KERR-MCGEE CORPORATION

RE: Application for Amendment to
License No. SUB-1010, Docket
No. 40-8027, to Permit Subsurface
Storage of Certain Liquids at
Kerr-McGee's Sequoyah Facility

SUMMARY LIST OF REVISION PAGES

Summary list of replacement pages, Revision 5/10/72

FIGURE IV-1
 Revision 5/10/72

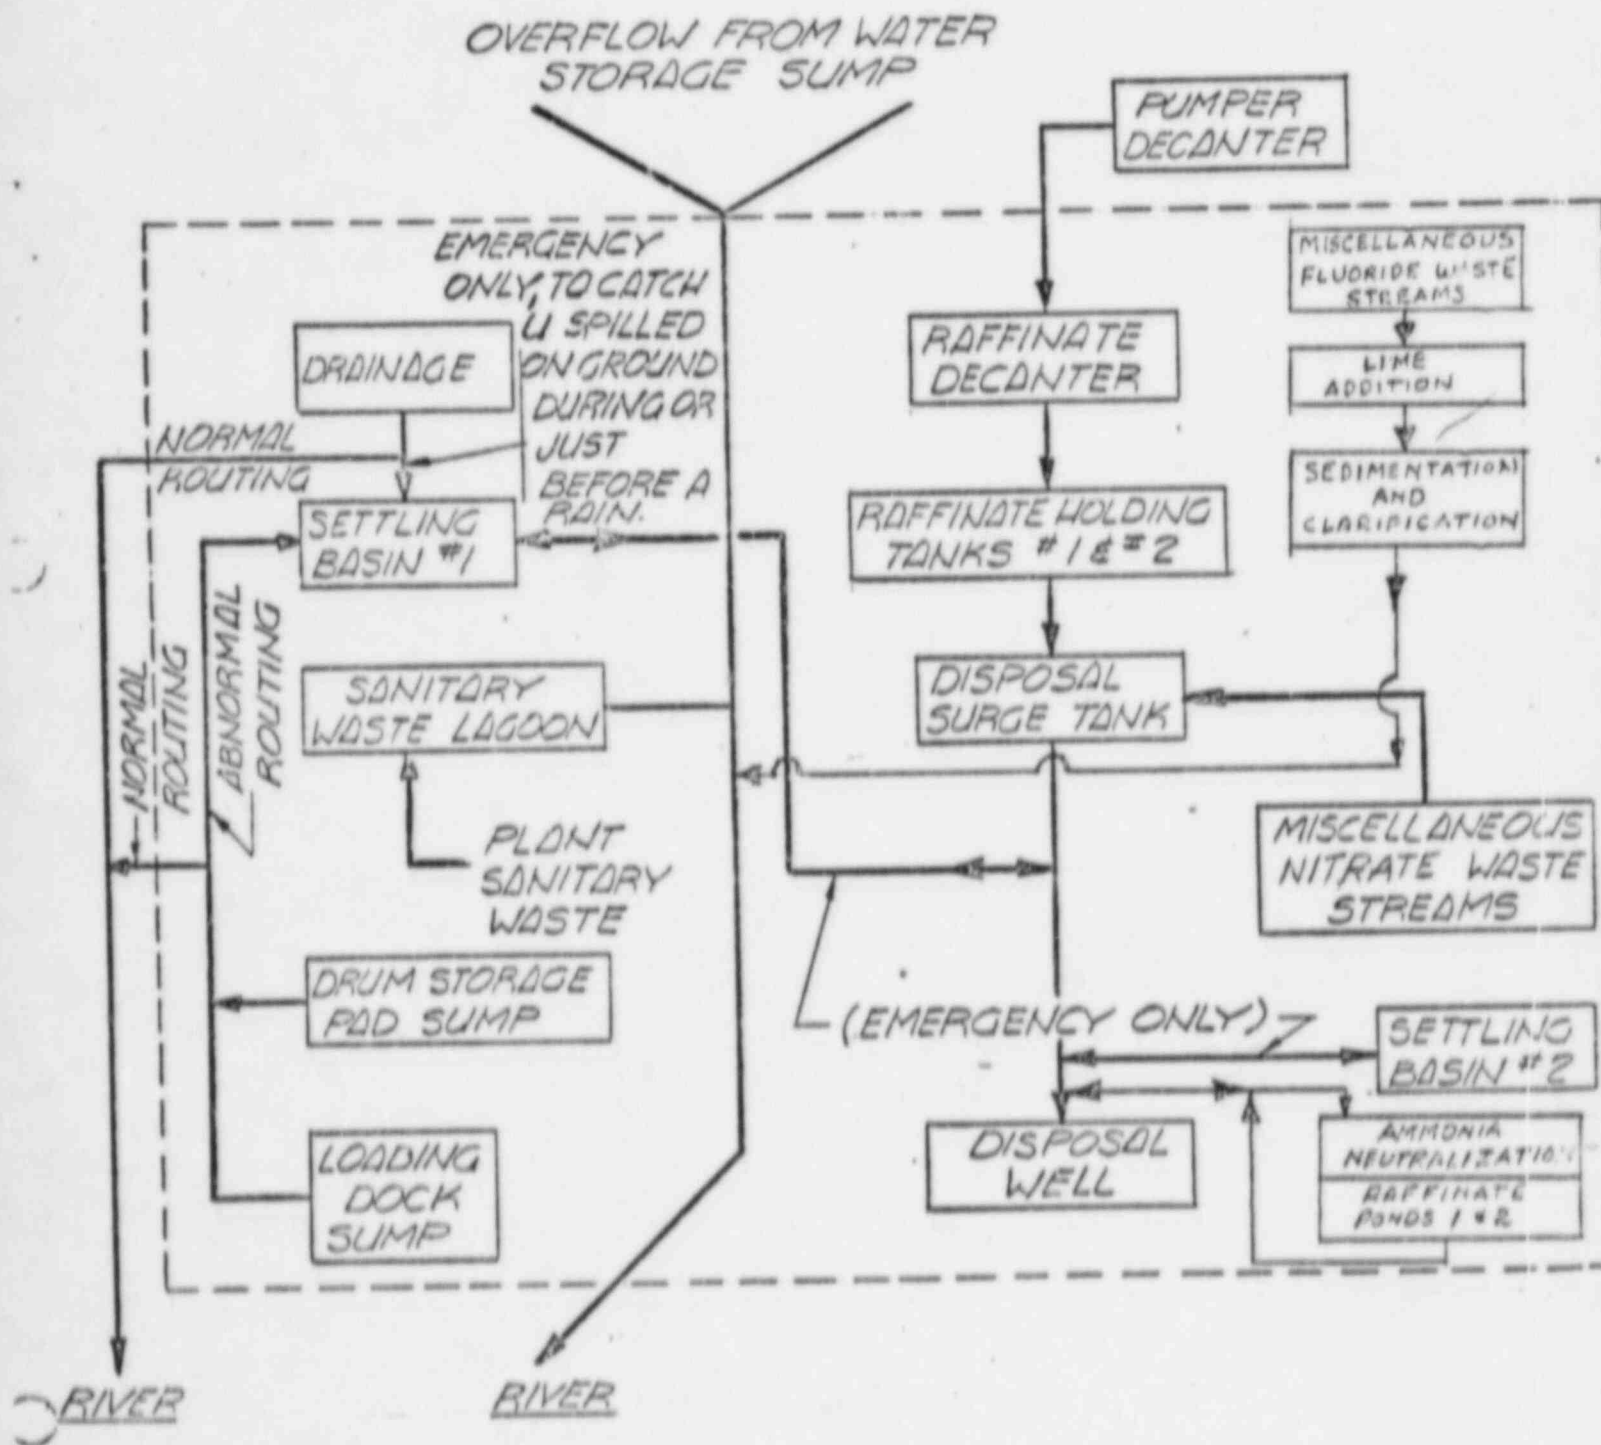
<u>New Pages</u> <u>(5/10/72)</u>	<u>Revision Reason</u>	<u>Replaces Pages</u> <u>(2/3/70)</u>
I-3	Added specific approval request to exceed 10CFR20 limits for well disposal.	I-3
Fig. III-2	Raffinate to well storage or surface pond.	Fig. III-2
III-3	Raffinate to well storage or surface pond.	III-3
IV-1 to IV-6.1 and Fig. IV-1 (7 pages)	Partial revision of Section IV - Waste Disposal to reflect waste well storage.	IV-1 to IV-6.1 (Figs. IV-1 and IV-2) (9 pages)
IV-7	Liquid waste releases.	IV-7
<hr/>		<hr/>
Total 11 new pages plus Appendix B		Total 13 pages to be removed.

A simplified sketch of the liquid waste system is shown on Figure IV-1. The Oklahoma Water Resources Board has approved the overall waste treatment plan within their jurisdiction.
